E8267D-02

S E R V I C E N O T E

E8267D PSG Vector Signal Generator

Incorrect voltage rating on the Analog Mod Gen capacitor C480

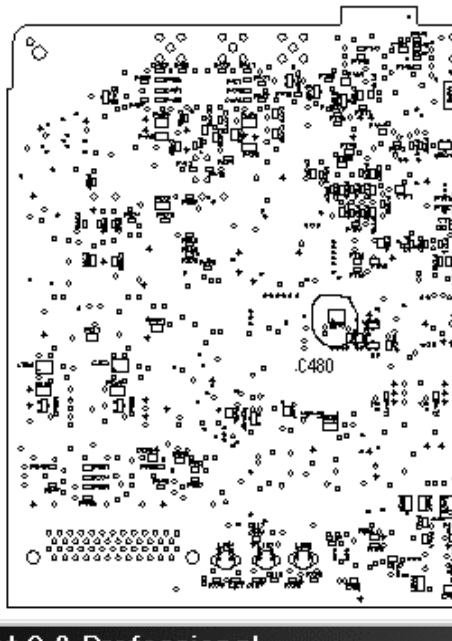
On Analog Mod Gen boards (E8251-60306) with VUF A0100, C480 a filter capacitor on a 15V line was loaded with a 10 V rated part. The capacitor needs to be removed and does not need to be replaced. Removing the capacitor will not cause any performance problems.

C480 is not labeled but can be located in reference to VR451. On the bottom side of the Analog Mod Gen board locate VR451. If the board has not been reworked, slightly to the left of VR451 will be a larger black body surface mount capacitor with a white stripe. The device will be labeled with “10-10 MD” plus the company logo. If C480 is missing or C480 is a yellowish orange color, it was reworked and the VUF was not changed. Using an ESD safe station, remove C480 and re-install the Analog Mod Gen.

When in for repair and/or calibration, check the E8251-60306 VUF number. If the VUF number is A0100, the Mod Gen board needs to be removed and inspected. If the VUF number is A0101, C480 has been changed to the correct voltage rated capacitor and no further action is required. To check the Analog Mod Gen VUF number press “Utility”, “Instrument Info/Help Mode”, and “Installed Board Info”.
